Service-Information Motorcycle

BMW of NA Service Department	Group: 36 Wheels and Tires	August 1984 36 022 84 (2117)	BMW NA For USA and Canada Only
---	---	--	---

Recall Campaign 84V – 092
Inspection/Replacement of 19" Front Cast Alloy Wheels

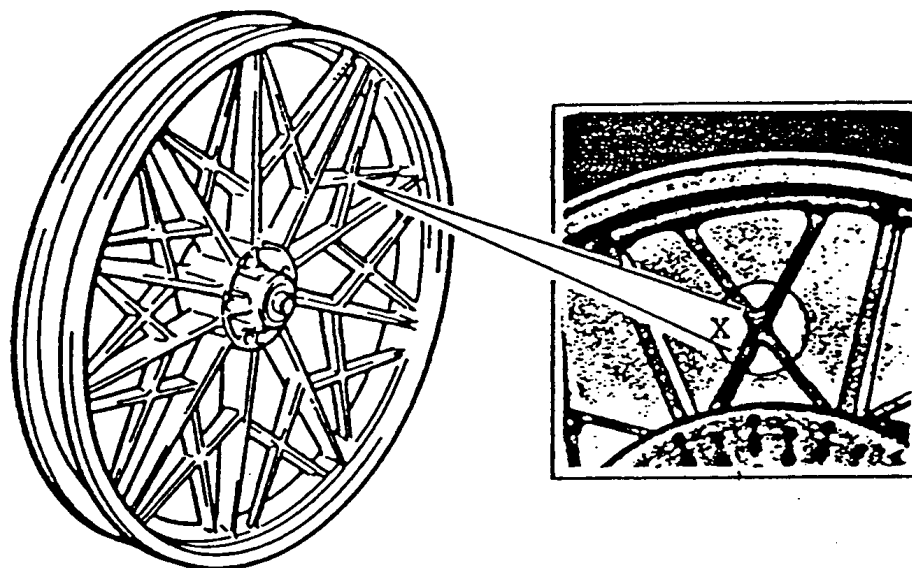
1. Determine the manufacturing/casting date without removing the wheel from the motorcycle. The location of this mark is at point "X" in the center of the cross over.

Check the casting date shown in normal Arabic numerals on one of the spoke crosses. Do not confuse it with a second, similar manufacturing mark comprising an Arabic and Roman figure.

2. If the casting date is 10/82 or later, check for reinforcement on spokes, no further action is necessary.
3. If the casting date is 9/82 or before, the wheel has to be exchanged.
4. A new inner tube must be installed at our cost when the tire is exchanged.
5. Balancing of the entire assembly should be performed and is part of our reimbursement to you.
6. Use BMW balance weights only:
